108-124 Forest Road, Mixed-use Development

DA Architectural Drawing List

ISSUE STATUS		
REV	DESCRIPTION	DATE
1	DA ISSUE	16/12/20
2	RESPONSE COUNCIL RFI - AMENDMENTS AS NOTED	30/07/21

TITLE	Floor Plan Basement 03
ISSUE	DA
REV.	2
DRAWING NO.	DA16

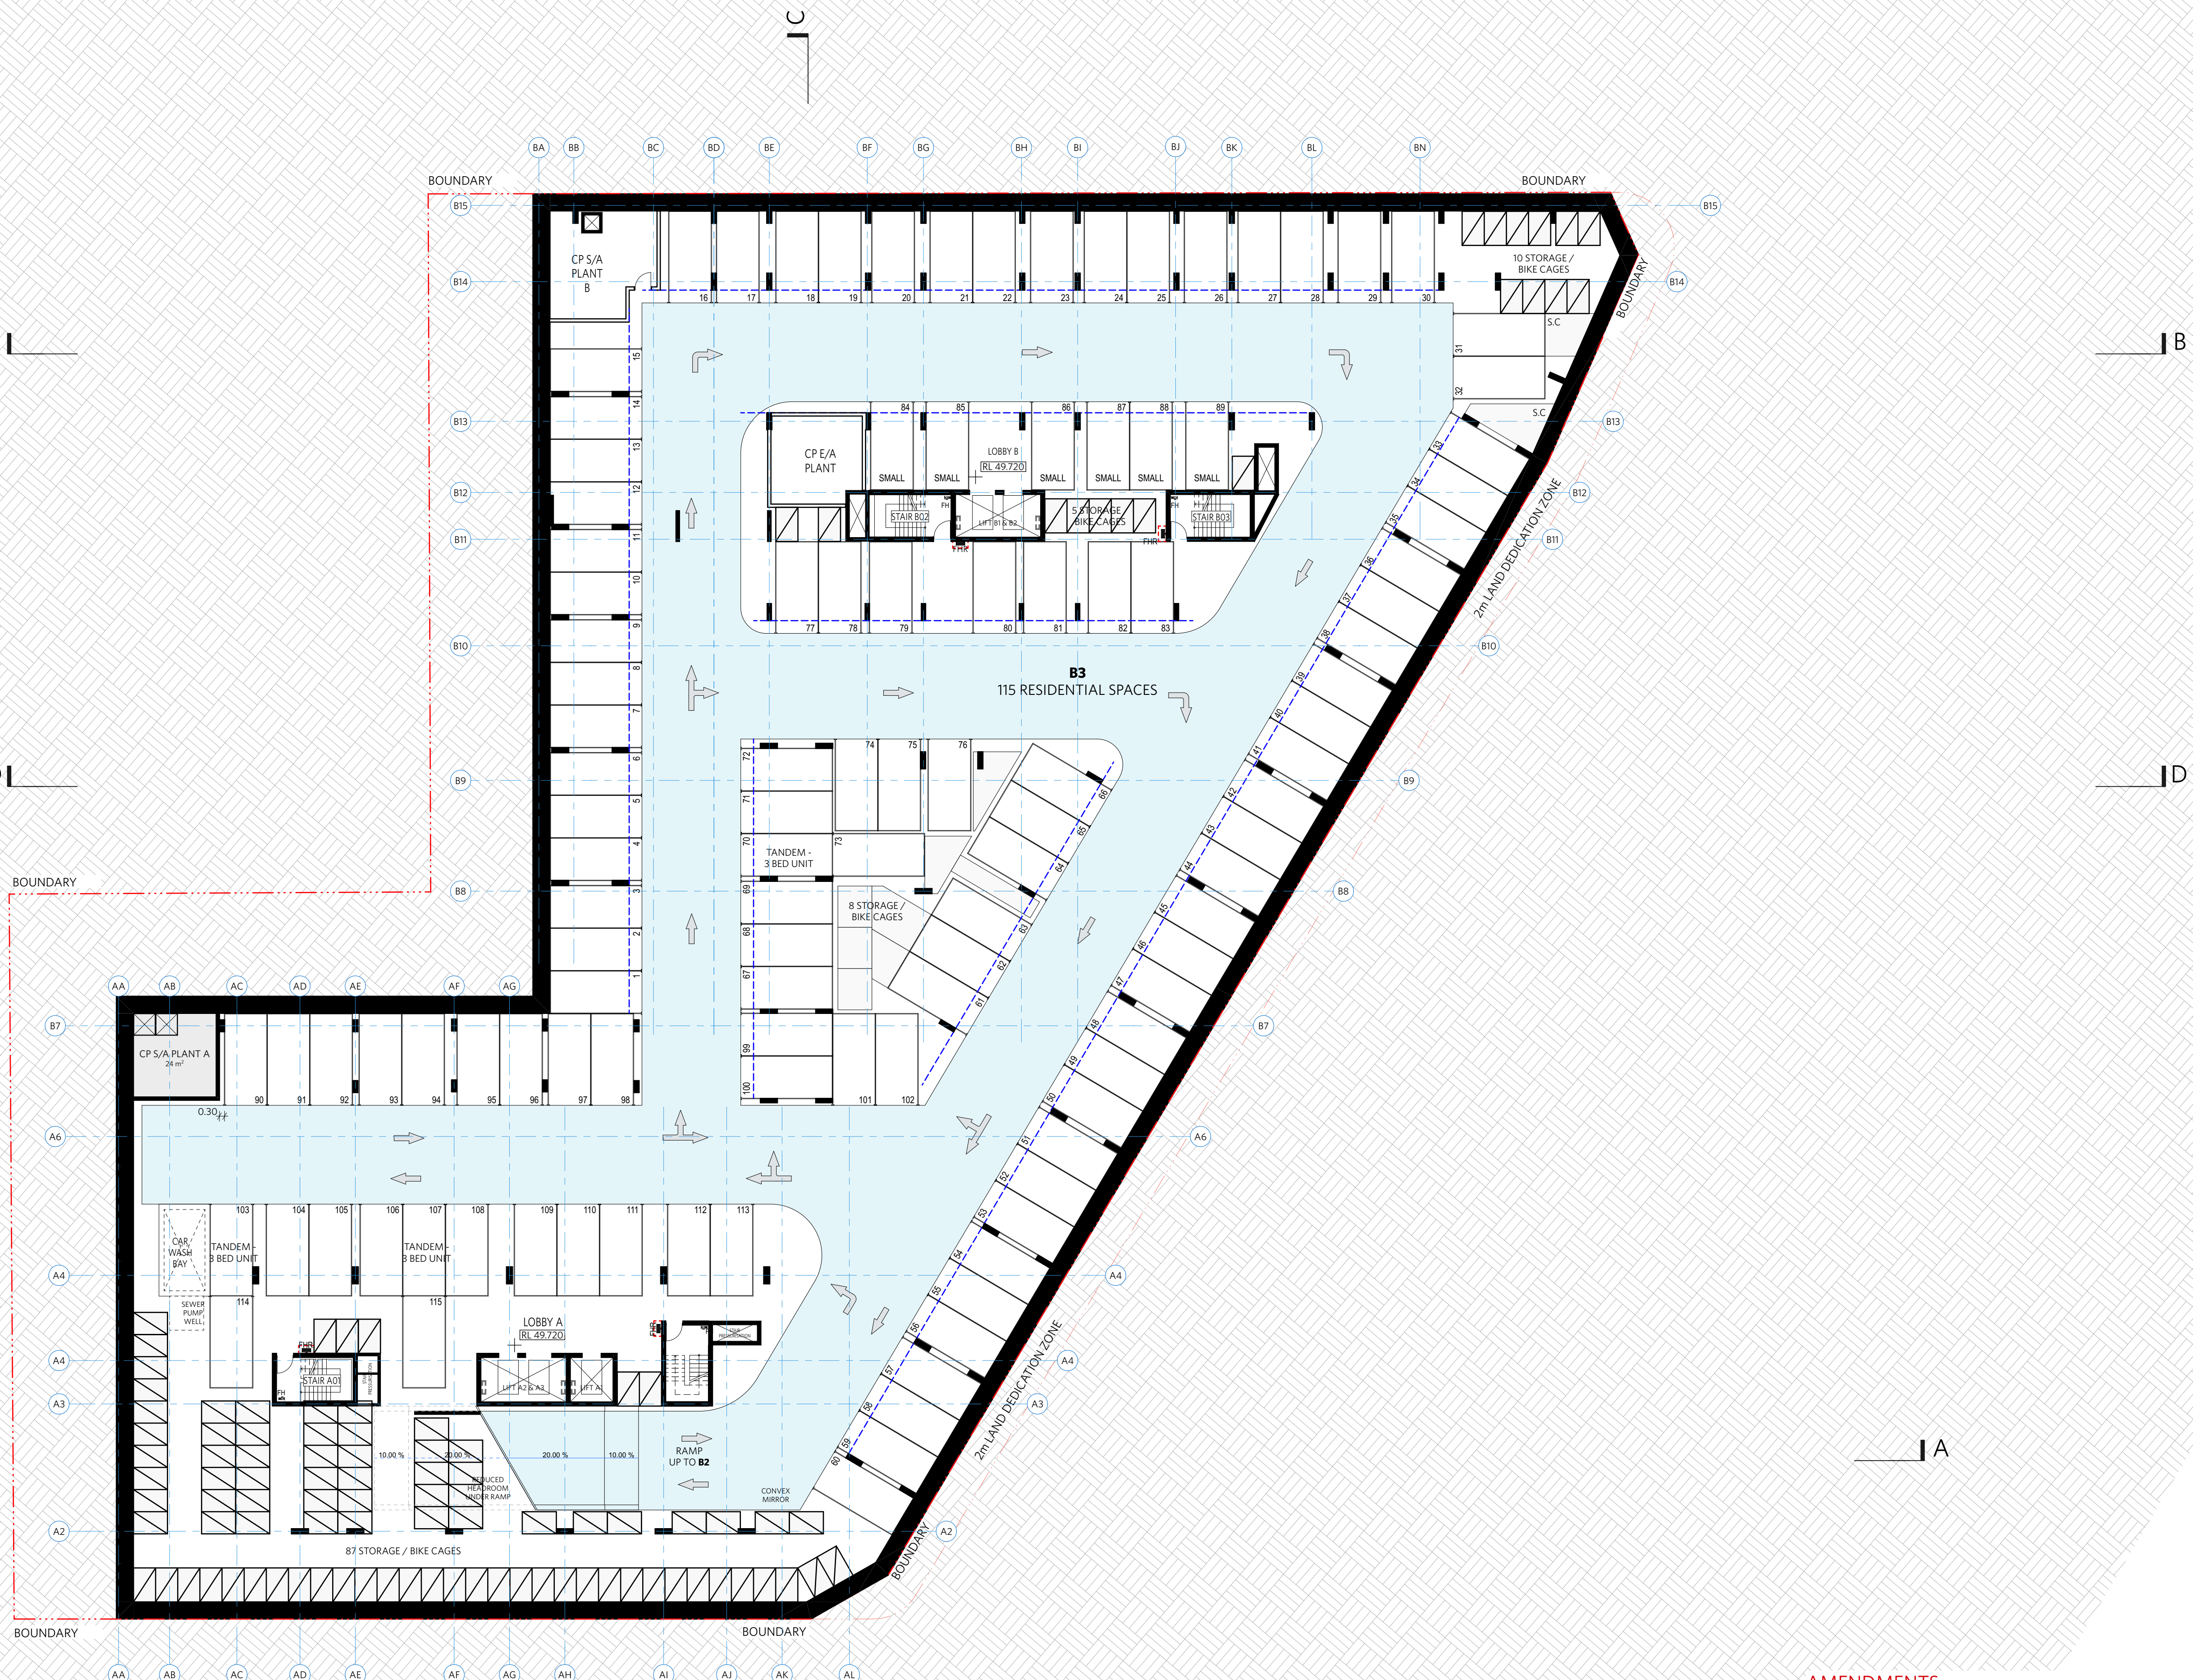
AMENDMENTS:
General Note: Basement 2 & 3 circulation route amended based on new ramp entry

TITLE		
Elevation Forest Rd (South)		
ISSUE	REV.	DRAWING NO.
DA	2	DA17

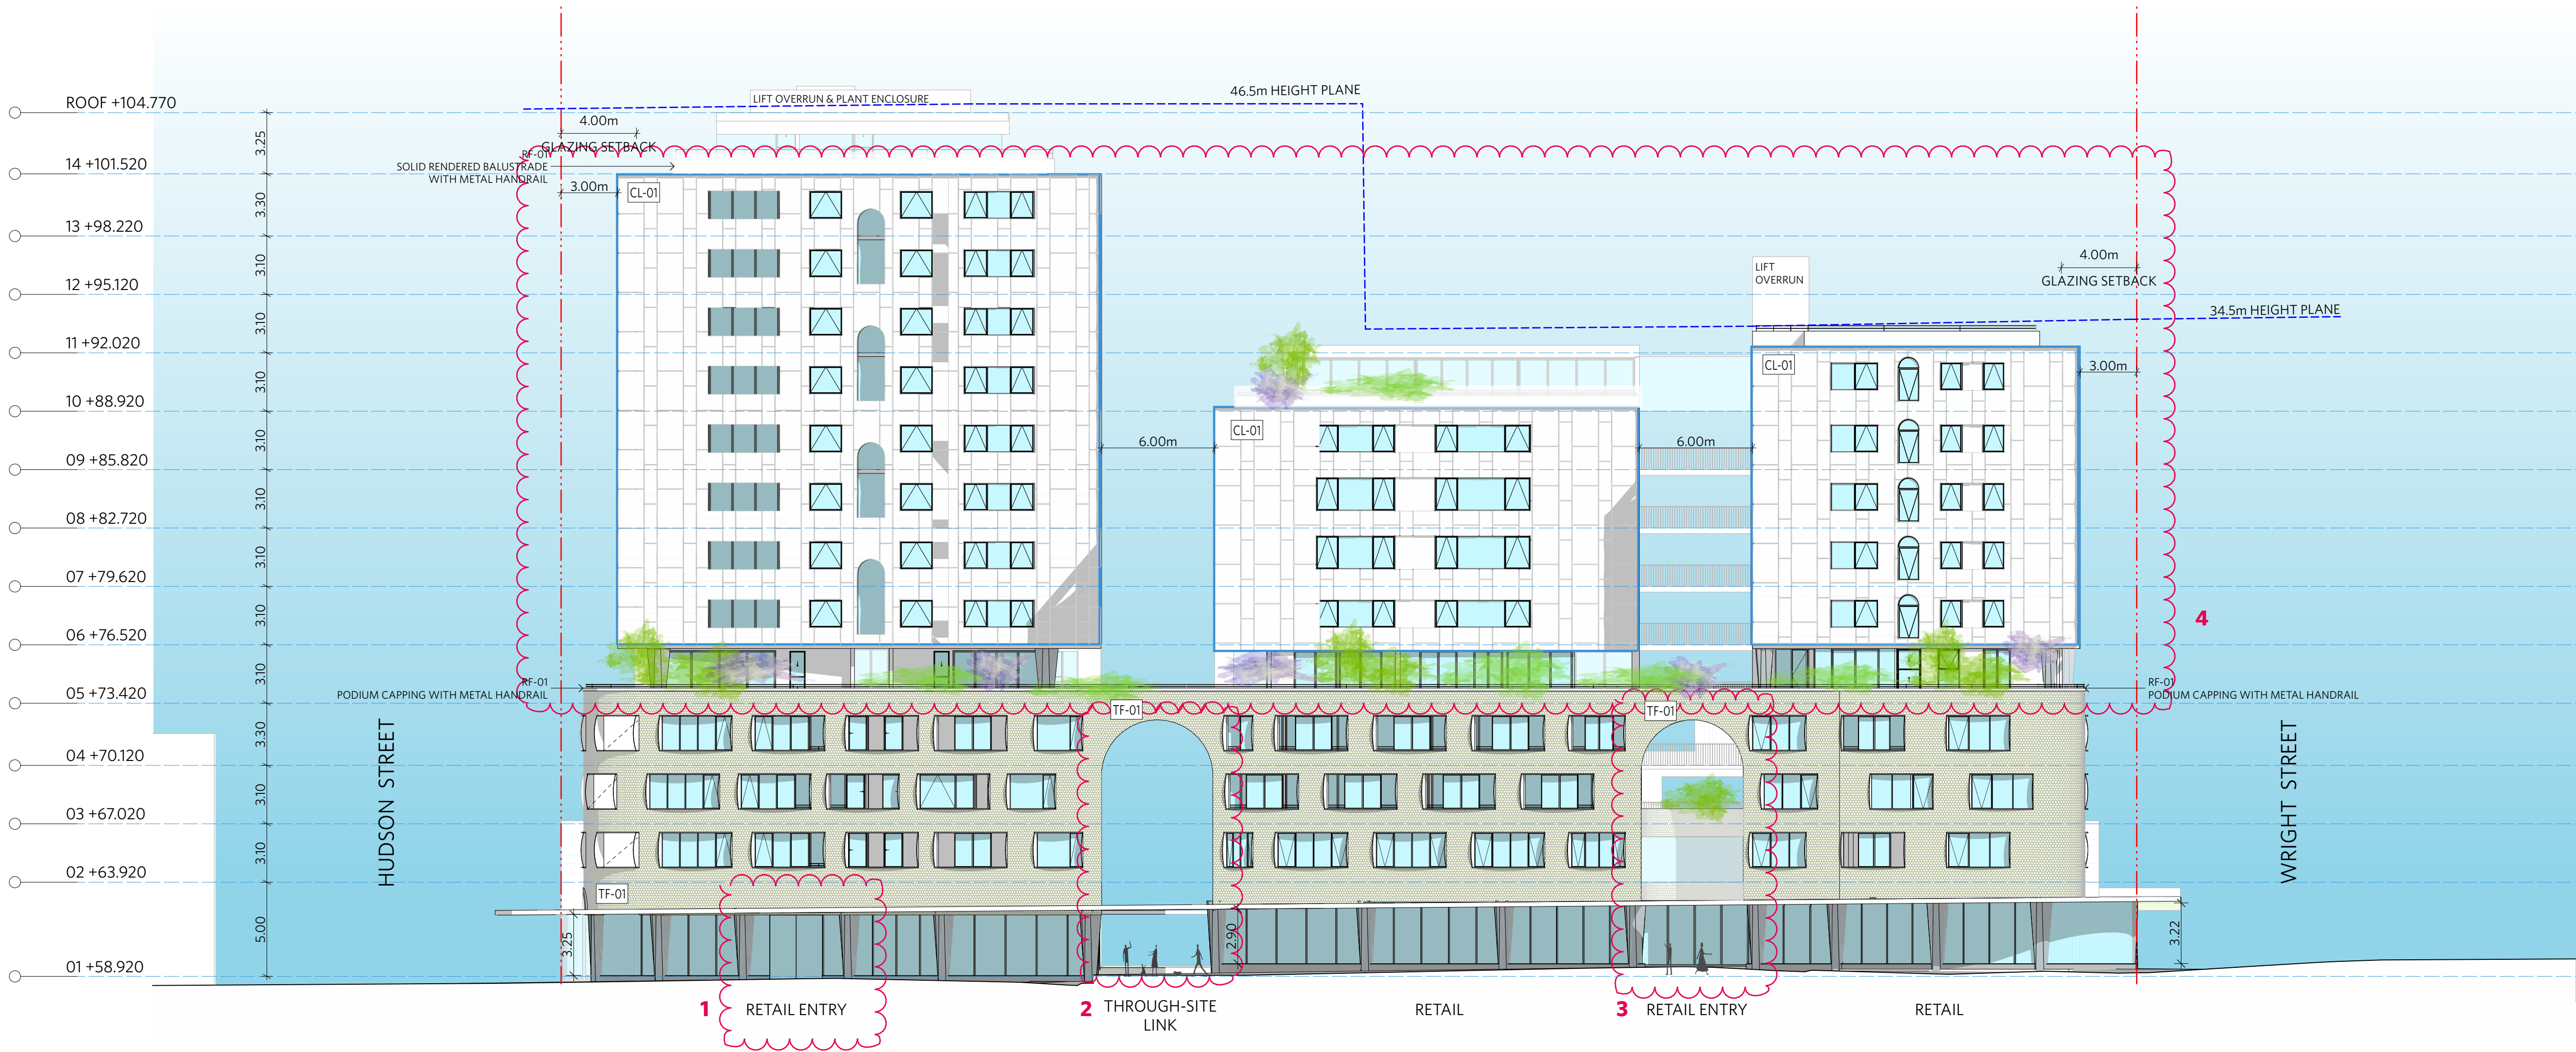
CLOUDED AMENDMENTS:
1) New Forest Rd entry added to retail tenancy
2) Height of through-site-link arch way increased
3) Height of through-site-link arch way increased & width of retail lobby B entry increased
4) Elevations amended to suit revised unit layouts

TITLE		
Section C-C		
ISSUE	REV.	DRAWING NO.
DA	2	DA23

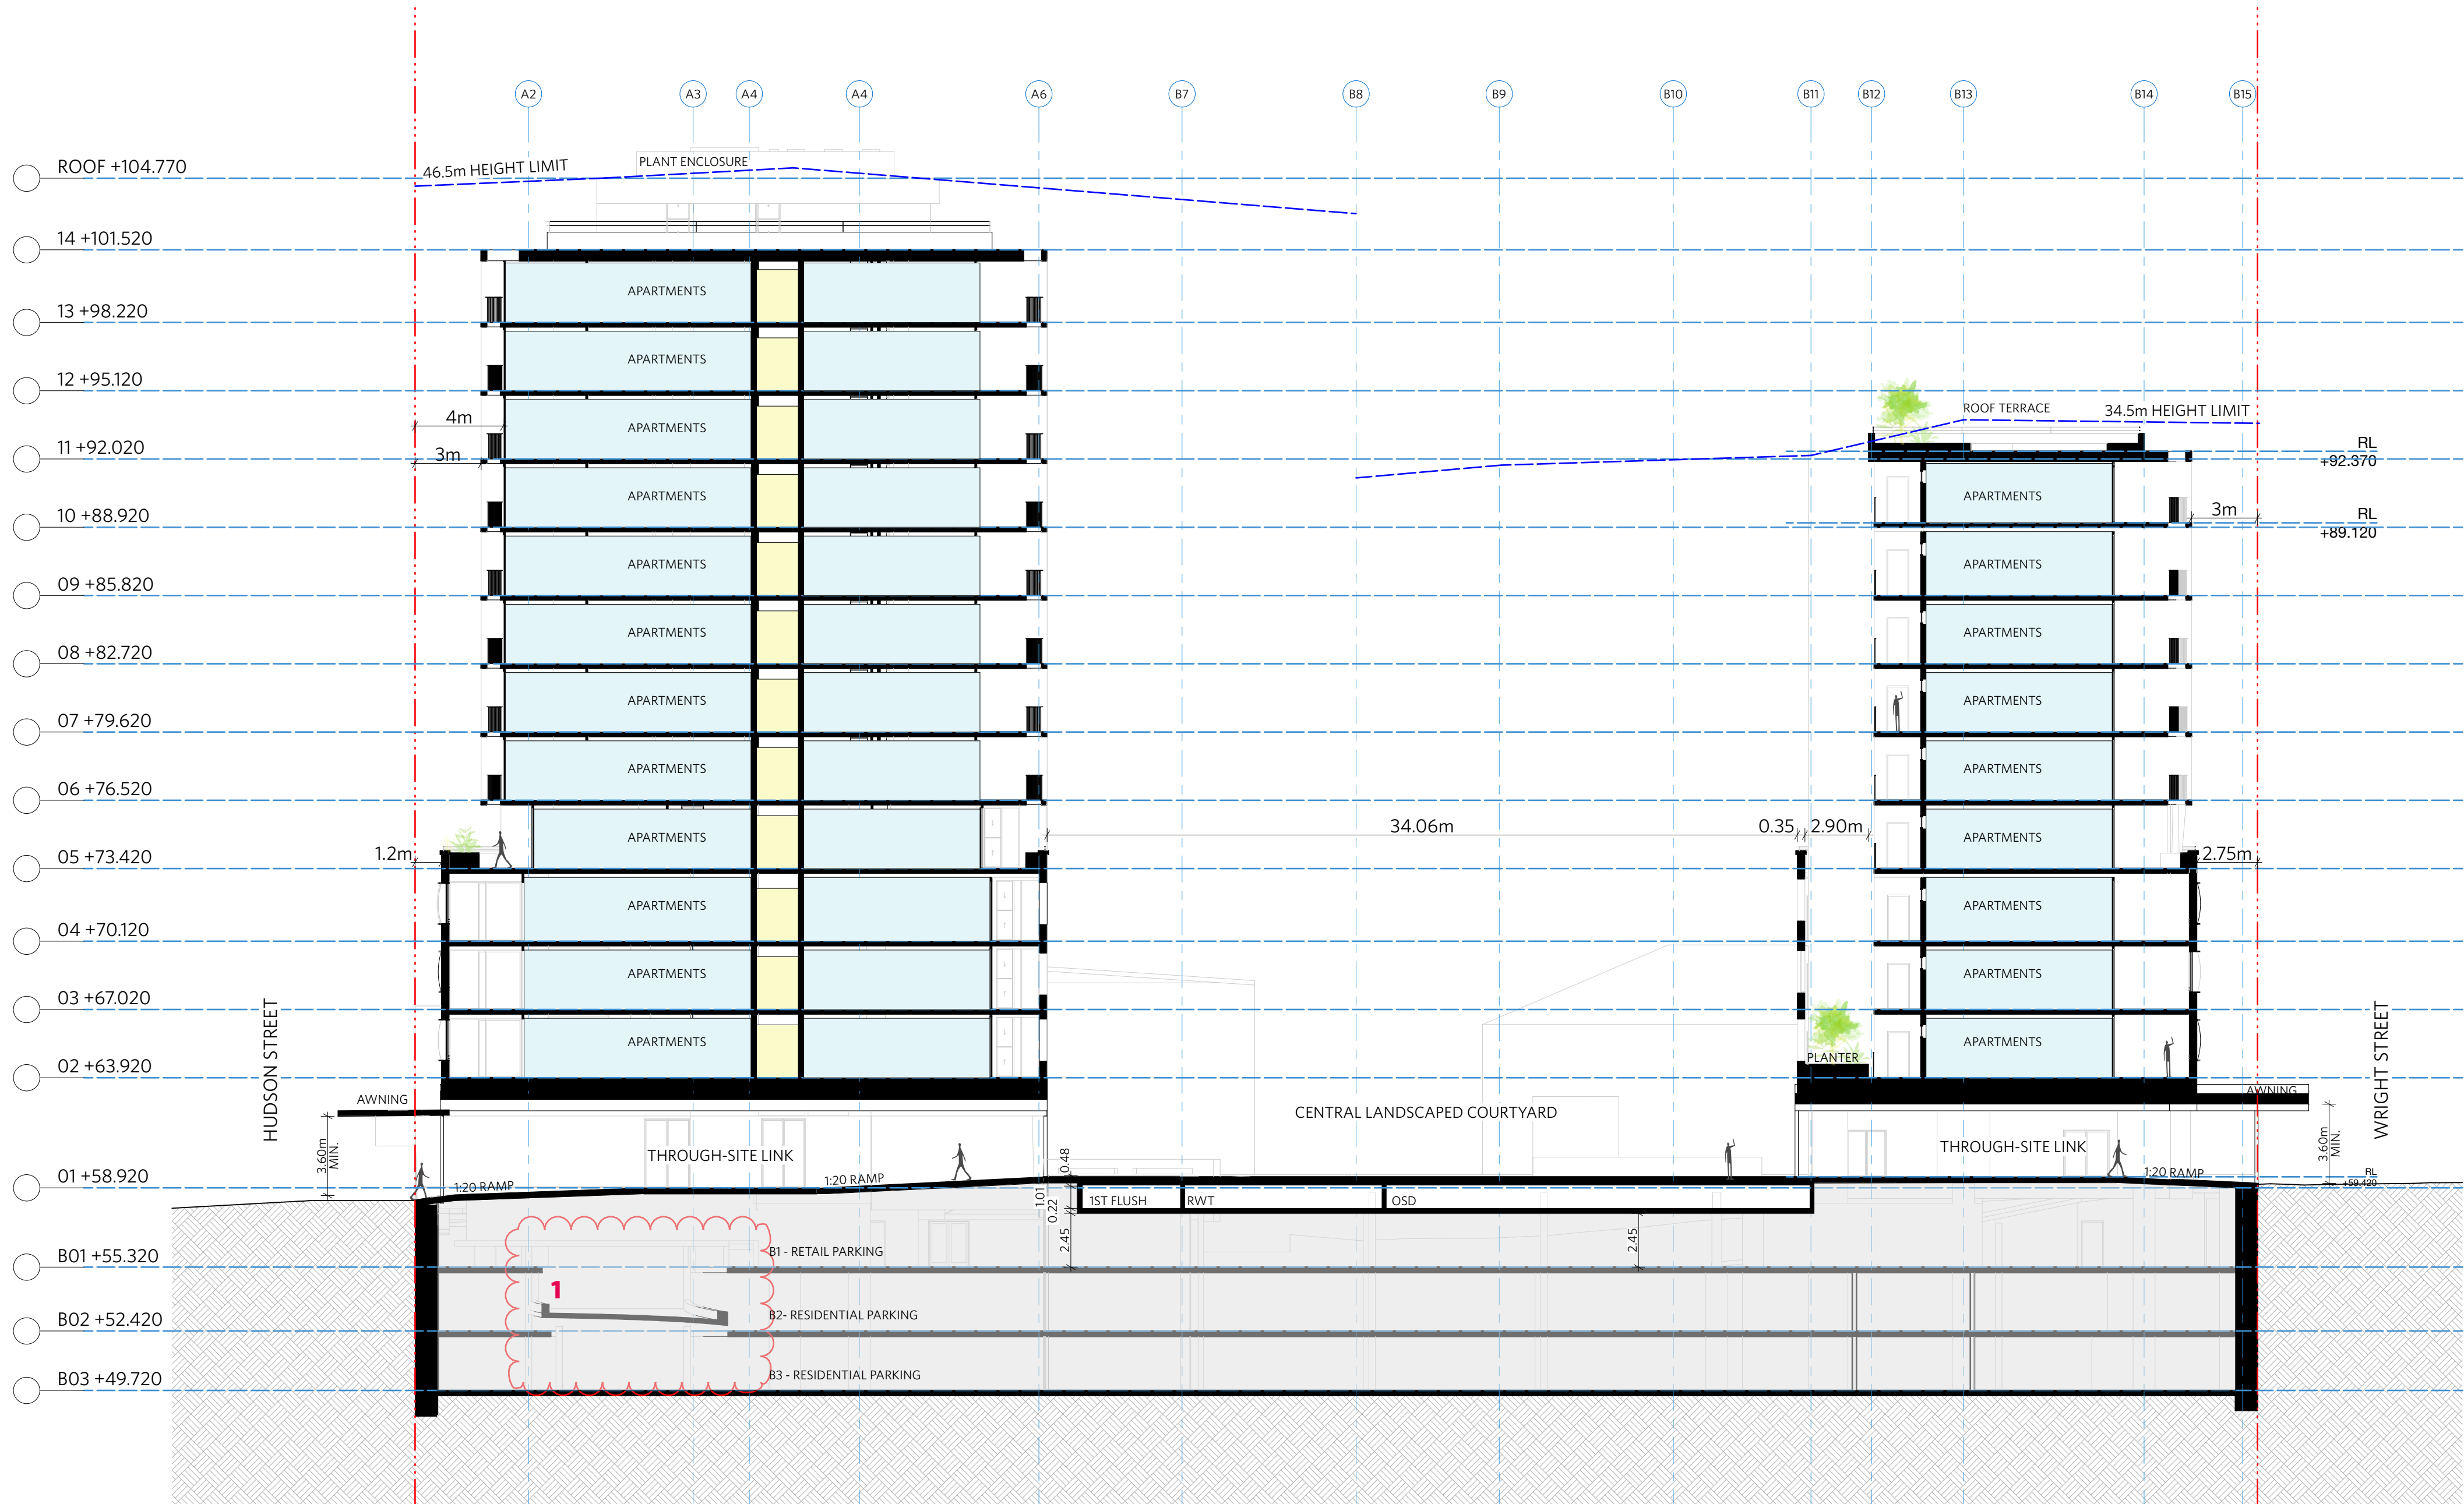
CLOUDED AMENDMENTS:
1) Location of basement entry & circulation ramps amended
